Project: South Battery Park City Resiliency
Project Design Services

RE: Addendum # 3
of Pages: (13)

EXHIBIT B
Page 11 (Revised)

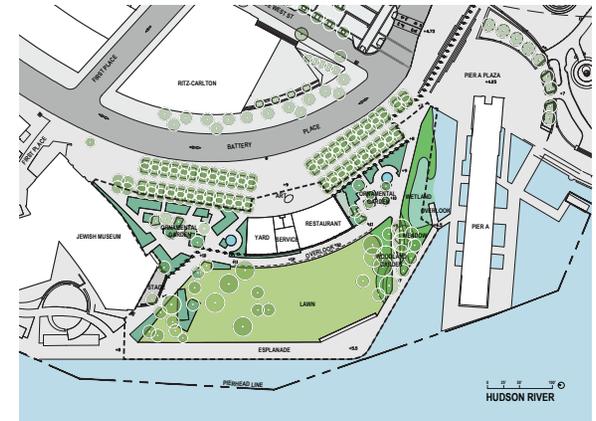
37. Is it correct to assume that the programs and areas for the Wagner Park landscape portion of the project are consistent with the data presented on page 11 (Wagner Park – Use Allocation) of Exhibit B? Is it correct to assume that the programs and areas for the Park Pavilion portion of the project are consistent with the data presented on page 15 (Park Pavilion Programming) of Exhibit B?

Response: *Page 11 of Exhibit B is hereby revised and attached below. The remaining pages remain in effect.*

9. Wagner Park — Use Allocation

- expanding the ornamental gardens;
- simplifying the lawn;
- increasing the planted areas to include a new wetlands feature at the Pier A cove; and
- reducing existing paved areas.

Landscape Category	Area
Garden	21,640 sf
Lawn	39,500 sf
Wetland + Woodland	0
Hardscape	44,400 sf
Building	7,000 sf
Yard	960 sf
Water	3,000 sf
Total	116,500 sf

Change in Area	Area
+ 1,360 sf	23,000 sf
+ 500 sf	40,000 sf
+ 9,600 sf	9,600 sf
- 10,500 sf	33,900 sf
0	7,000 sf
+ 2,040 sf	3,000 sf
- 3,000 sf	0 sf
Total	116,500 sf
